MEMORANDUM

SUBJECT: Minor Heritage Permit Application

1 Station Street, Markham Village Unauthorized Driveway Expansion

FILE: HE 23 135721

Appendix 'C'Drawing prepared by the Operations Department

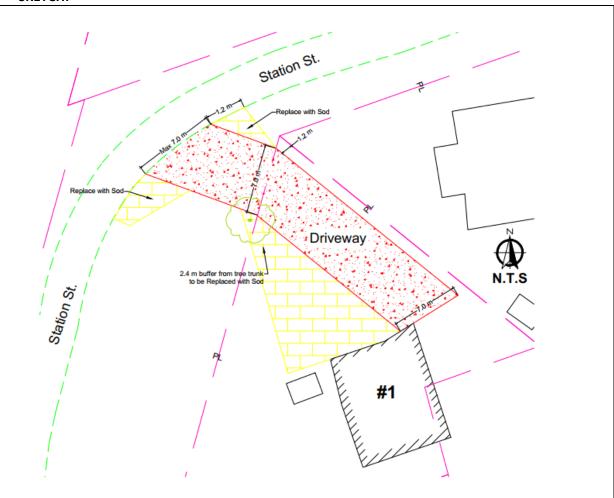
- A drawing prepared by the City's Operations Department is included as Appendix 'C' of this memo and shows the permitted extent of the driveway on City-owned land (the property line is drawn in pink). Removal of the interlock in the area hatched in yellow adjacent to Station Street is required in order to conform to the maximum driveway width as permitted by the zoning by-law. As per By-law Enforcement the size of the driveway is limited to the greater of either: the garage door width plus 2.0 metres, or 6.1 metres;

- The interlock adjacent to the dwelling is on privately-owned land. While hardscaping of the hatched yellow area as shown in the appended drawing does not contravene the zoning by-law, parking is not permitted in this area;

- Staff do not object to the paved area adjacent to the dwelling provided that the interlock is differentiated from the interlock used for the driveway. At present there is no differentiation between the two. Parking in this area is also not supported;

- Staff do not support the Minor HE Permit application as the size of the driveway is not compatible with the heritage character of the Subject Property nor does it comply with the requirements of the zoning by-law for maximum driveway width;
- In order to comply with the requirements of the zoning by-law and ensure compatibility with the heritage character of the Subject Property, the following is required/recommended: (a) the portions of interlock hatched in yellow in the attached drawing are required to be removed from City-owned land and; (b) the paving material in

the hatched area adjacent to the heritage dwelling is recommended to be replaced with a material that is differentiated from the driveway or just removed and replaced with soft landscaping.

THAT Heritage Markham does not support the extent of paving at 1 Station Street and recommends that the Minor Heritage Permit be approved with the condition that the unauthorized driveway expansion on City-owned land be reversed and the interlock adjacent to the heritage dwelling be replaced with new paving material to differentiate it from the driveway or removed and replaced with soft landscaping.

- The driveway opening shall be a maximum of 7.0 m, and the edge of the driveway must be at least 1.2 m away from property lines and boulevard trees (see notes on attached drawings).
- The driveway shall meet the edge of the roadway at 90° to maximize visibility, with an allowable deviation of 20° is to accommodate for corner and uniquely shaped properties.
- Any excess interlock beyond the driveway apron (area within the Right Of Way) shall be removed and replaced with sod.
- . Remove the pavers on the East side of the tree to a minimum of 1.2m distance from the tree trunk
- Remove the pavers on the North, South & West sides of the tree to a minimum of 2.4m distance from the tree trunk.
